# **Intel 82374/5 EB/SB EISA Bridge PCIset Specification Update**

Release Date: April, 1997

Order Number 297735-002

Figure 2: PLD Workaround #1

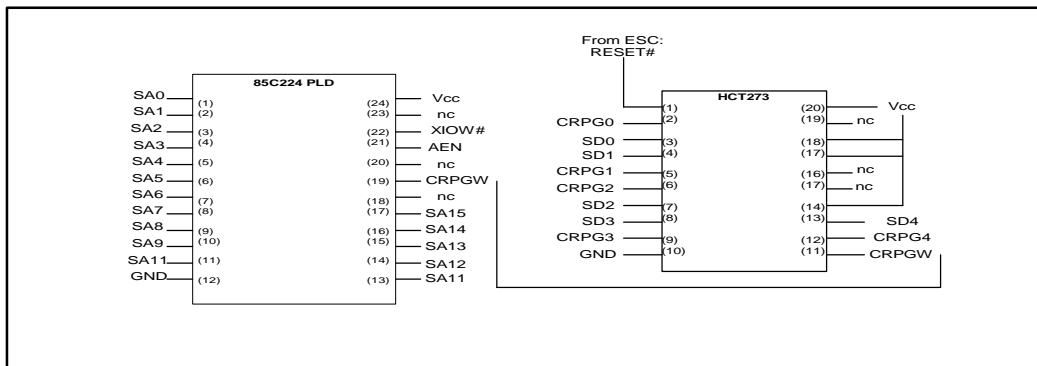
**PROBLEM:** EISA configuration RAM data. The 82374EB may not generate the proper page address on the LA[31:27]# lines during configuration RAM accesses under the following conditions: A DMA cycle or ISA refresh cycle, followed by another pending DMA, followed by an access to EISA configuration RAM (an EISA master should create the same problem).

**WORKAROUND :** Below are two possible solutions:

1. The 85C224 PLD in fig. 2 is programmed to generate an IO write to I/O port 0C00h, which the ESC integrates as a configuration RAM page register. Upon seeing 0C00h on the address bus (SA[15:0]), AEN

asserted high for EISA bus master cycles, and an XIOW# asserted low, the PLD will drive its only output, CRPGW asserted high, as the clock signal input for the HCT273.

The reason for the driving the output high is that the HCT273 needs to see a rising edge on this clock signal in order to latch the correct CRAM page address. The HCT273 is an Octal D-type flip flop which is enabled on the rising edge of its clock signal input. The HCT273 will latch the correct CRAM page address off the data bus (SD[4:0]) and drive the address on its output signals (CRPG[4:0]). CRPG[4:0] are the synthesized versions of LA[31:27] and are tied to the corresponding inputs on the NVRAM. This solution is transparent to the system BIOS.

The actual pin assignments are given in fig. 2 above. This also includes the asserted values of the inputs and outputs (/ = symbol for asserted low). The following is the PLD equation (written in PLDshell Plus) for the data setup of the correct CRAM page address:

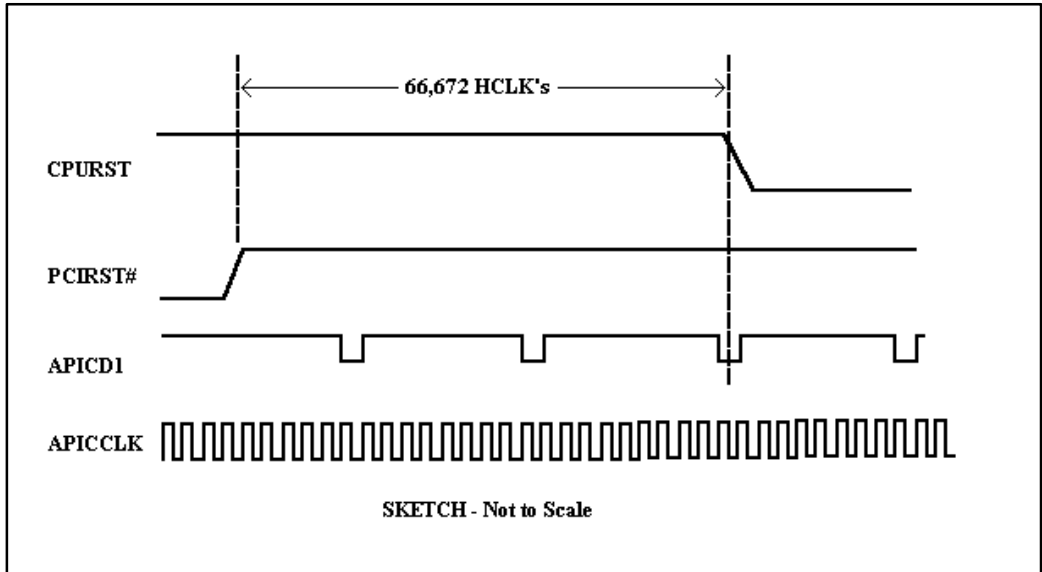
This issue affects dual-processing (DP) EISA systems using the Pentium® Processor at ICOMP index 735\90 (or 815\100) and the A-1 stepping of the 82434NX PCMC host bridge. Single processor designs are not affected.

The CPUs APIC data lines, APICD0 and APICD1, have secondary functions when CPU RESET (CPURST) is active. APICD1 is the APICEN (APIC enable) pin while APICD0 is the DPEN# (dual processor enable) pin. The local APICs are enabled if APICEN is sampled active high on the falling edge of CPURST. Also during RESET, the second CPU will drive DPEN# active low to indicate to the boot processor that it is present.

From the time that PCIRST# deasserts until the time that CPURST deasserts, the I/O APIC periodically pulses APICD1 low for one out of every 20 APICCLK's. If the pulse on APICD1 (APICEN) aligns with the falling edge of CPU RESET (CPURST), the local APIC's will not be enabled; this prevents proper DP or DP-ready functionality. See the figure below.

**Workaround #1:** Calculate the window for the APICD1 pulse relative to CPURST for a given host clock (HCLK) and APIC Clock (APICCLK) frequency. The following example demonstrates that by using a 60.0 MHz HCLK and a 16.0 MHz APICCLK (0.01% accuracy for both) the APICD1 pulse will be outside the sampling window of CPURST. With these equations, equally acceptable windows can be found for other values of HCLK and APICCLK.

**Workaround “A”**

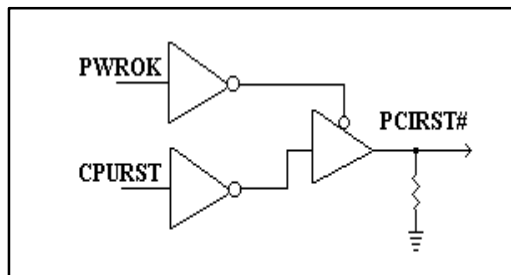
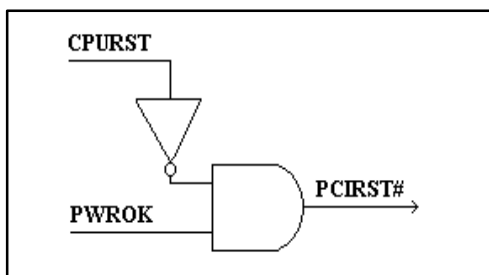
**Workaround #2:** Add logic to ensure that PCIRST# remains asserted low until PWROK is valid and then once PWROK is valid, let PCIRST# become the logical inverse of CPURST. This ensures that the I/O APIC and both CPU's exit reset simultaneously thereby preventing the I/O APIC from responding to the phantom APIC messages.

a) Connect a buffered version of CPURST to an inverter and then connect the output of this inverter to the input of a three-state buffer. PWROK# is used as the active low enable to the three-state buffer. The output of this three-state buffer is used as the PCIRST# signal for the entire system. Note that the PCMC PCIRST# output pin (pin 147) should be disconnected from the system.

It is important to use a buffered version of CPURST and preferably one that already exists in the system due to the critical AC timing of this signal. A weak pulldown resistor (8.2K, for instance) should be added to the PCIRST# net to ensure it is low while PWROK is low.

b) Connect a buffered version of CPURST to an inverter and then connect the output of this inverter to one input of a two-input AND gate. PWROK is the second input to the AND gate. The output of the AND gate becomes PCIRST# for the entire system. Again, the PCMC PCIRST# output pin (pin 147) should be disconnected from the system.

**NOTE:** Due to the combinational logic in workaround "b", there is a short time period (potentially several HCLKs) between the assertion of PWROK and the assertion of CPURST when PCIRST# actually deasserts. This deassertion of PCIRST# does not cause any system problems since it takes at least several hundred nanoseconds before any signals in the ESC will respond.

PCEB Side of AFLUSH# which drives AFLSH\_ESC#

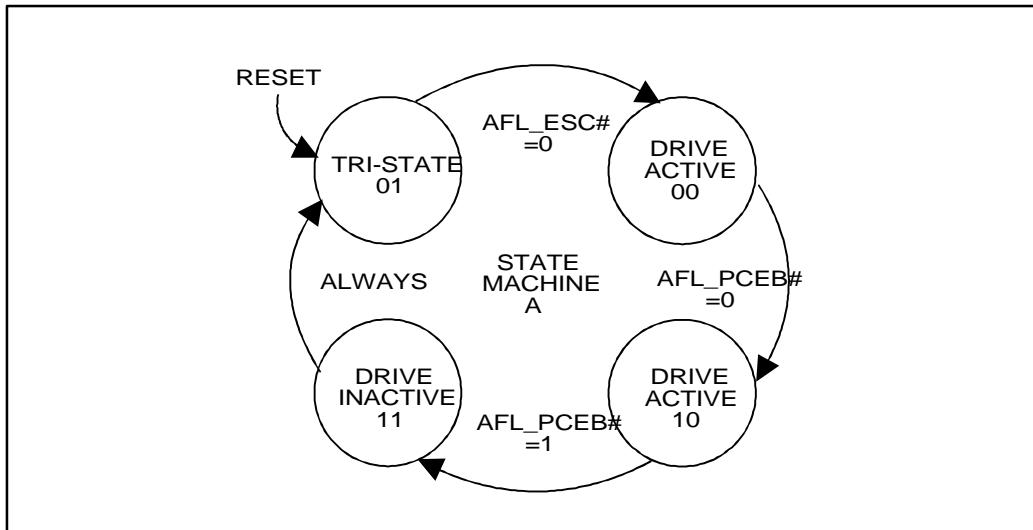
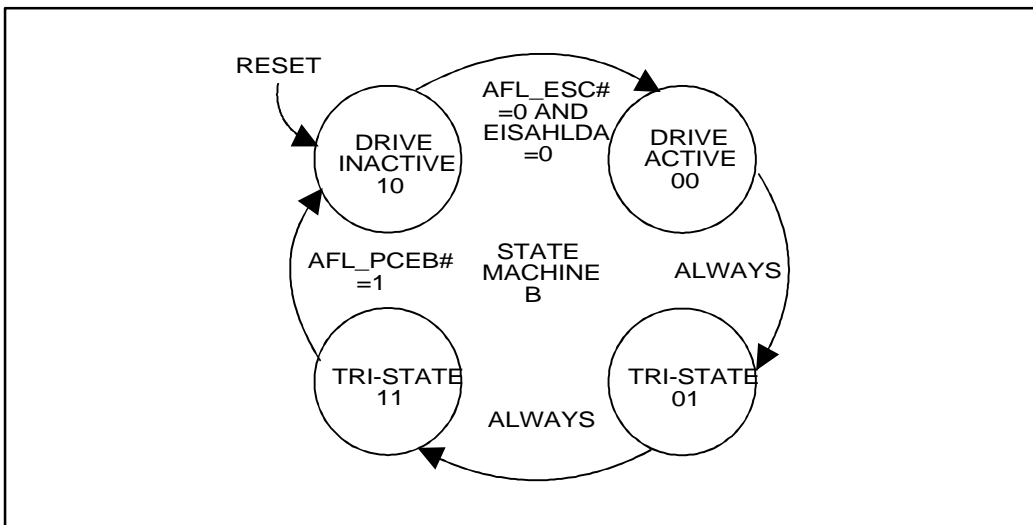
**PROBLEM:** In DP mode and during EISA/ISA/DMA transfers to PCI, an internal AC timing in the PCEB line buffers is violated, resulting in incorrect data driven onto the PCI bus. The failing scenario occurs during an APIC interrupt while the line buffers are flushing data and at the same time filling data. During that time, there is a window where the line buffer pointers do not change correctly.

The second workaround is designed to intercept the AFLUSH# signal between the PCEB and ESC (see figure below) in order to temporarily inhibit the assertion of the AFLUSH# signal to the PCEB. The AFLUSH# signal is held negated if there is an EISA-to-PCI transaction taking place. Once EISAHLDA is negated, the workaround will initiate the AFLUSH# protocol between the ESC and PCEB which will allow the APIC interrupt message to be sent to the processors. The workaround employs two state machines (using the PCI clock) that emulate the AFLUSH# logic from the both the PCEB and ESC perspectives.

- State Machine A (SMA) waits for the AFLUSH# signal from the ESC
- Once the ESC drives AFLUSH#, SMA will assert and hold AFLSH\_ESC#
- State Machine B (SMB) waits for the bus via EISAHLDA
- Once EISAHLDA is 0 (bus not busy) SMB asserts AFL\_PCEB# for 1 clock
- The PCEB assert AFLUSH# until buffers are flushed
- The PCEB signals the buffers are flushed by negating AFLUSH#

- g) SMA drives AFLSH\_ESC# inactive, then tri-states
- h) SMB comes out of tri-state and negates AFLSH\_PCEB# which is the default position for the ESC
